**KANSAS CITY  
MISSOURI**

# Ordinance 240335

TI & O Committee

# Standards Change Process

# ADA Ramps (1 of 4)-SW-1

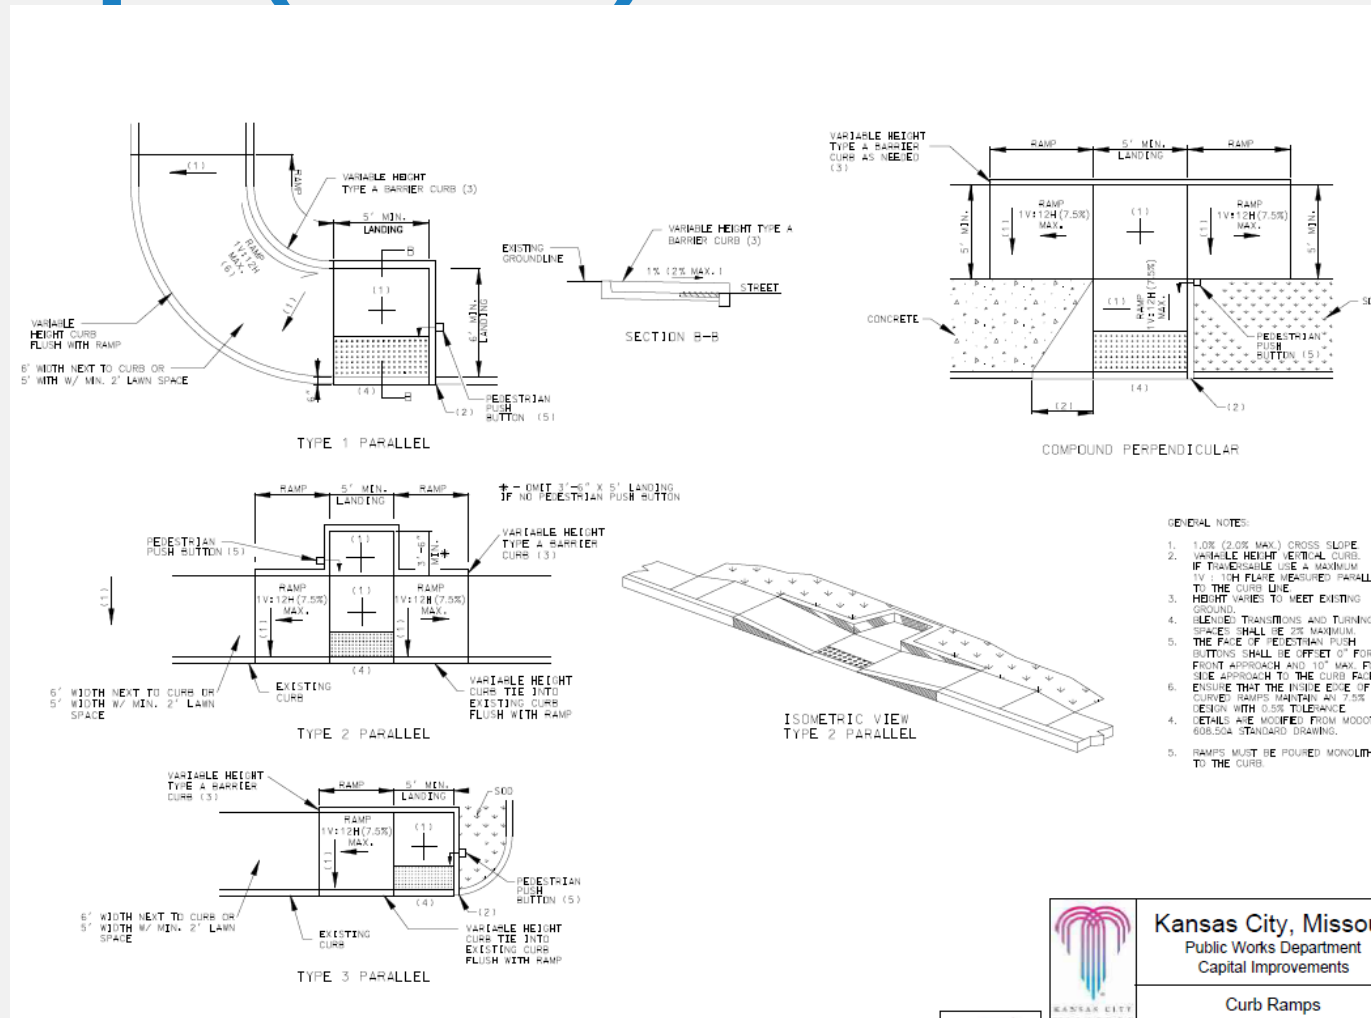
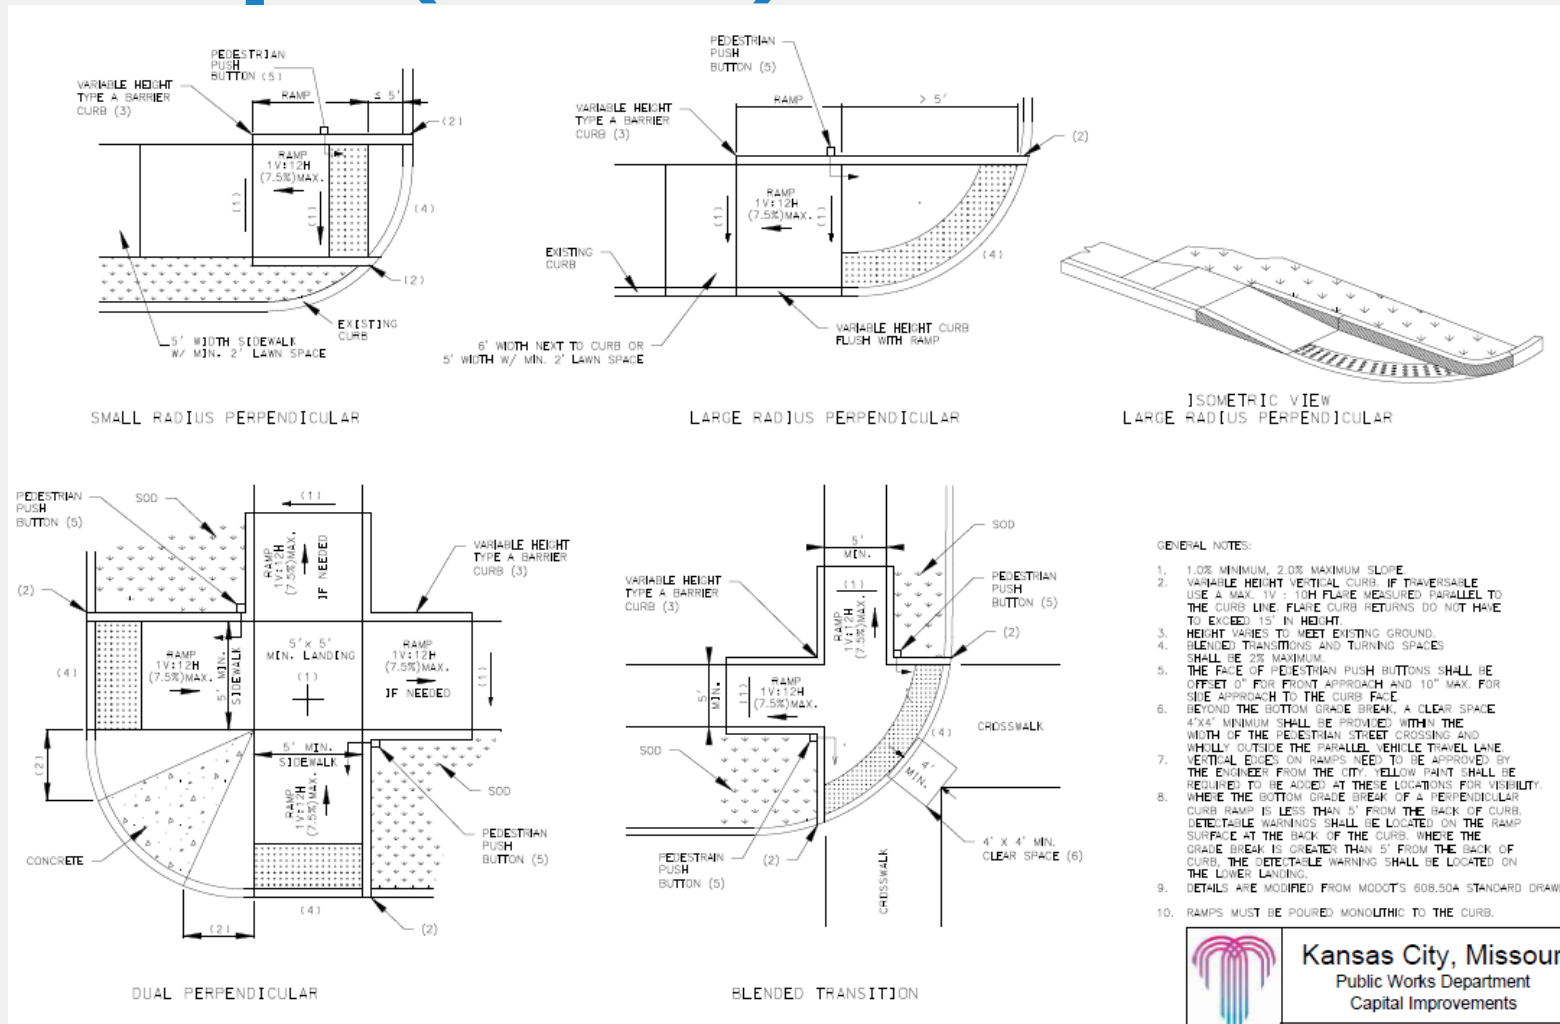
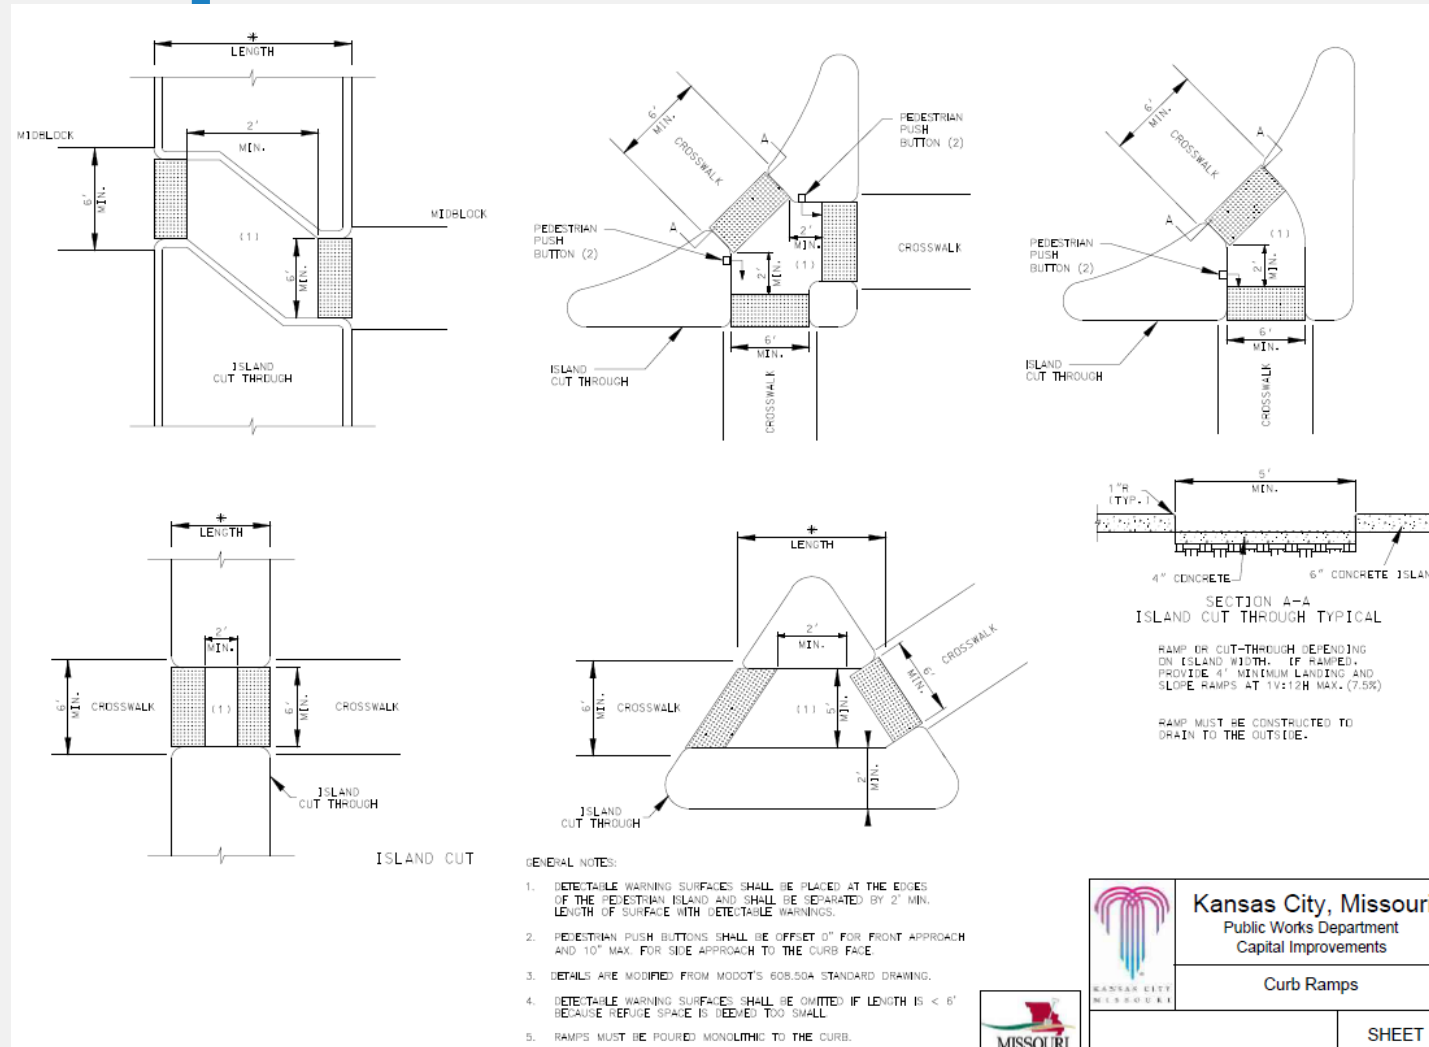
- Consolidated the previous ADA Ramps to be aligned with PROWAG and MoDOT
- Added flares as preferred approach than vertical curb ramps
- Vertical curb ramps exception to be approved by an Engineer from the City
- Added standards for construction to be poured monolithic to the curb
- Added standards for island for pedestrian crossing

# Alley Typical Detail (Concrete)-AS-2-C

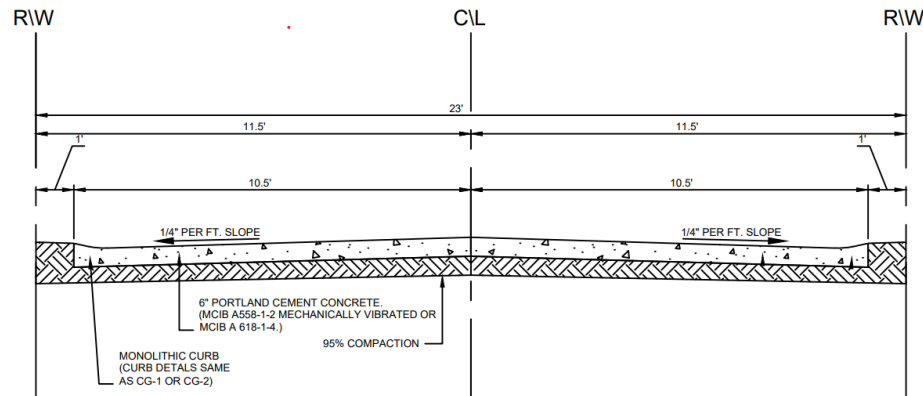
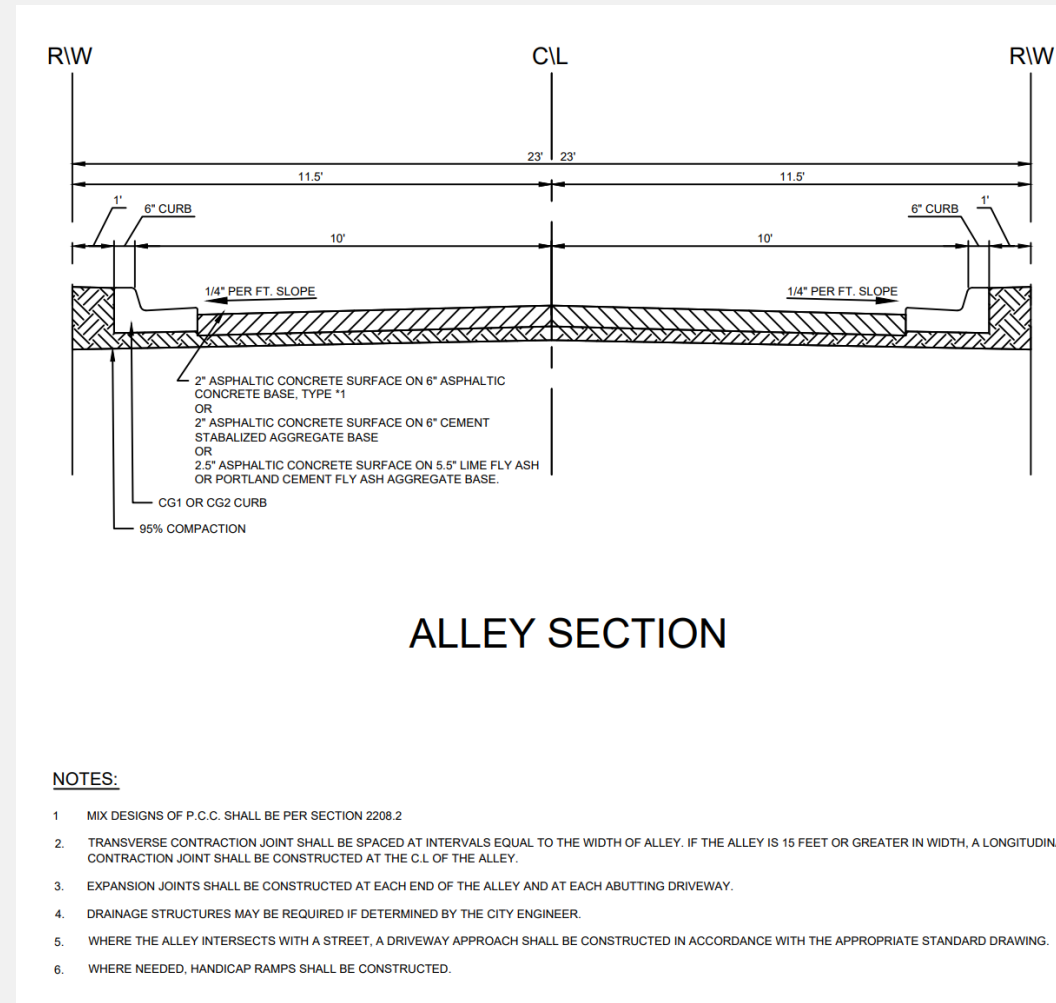
Added new standard
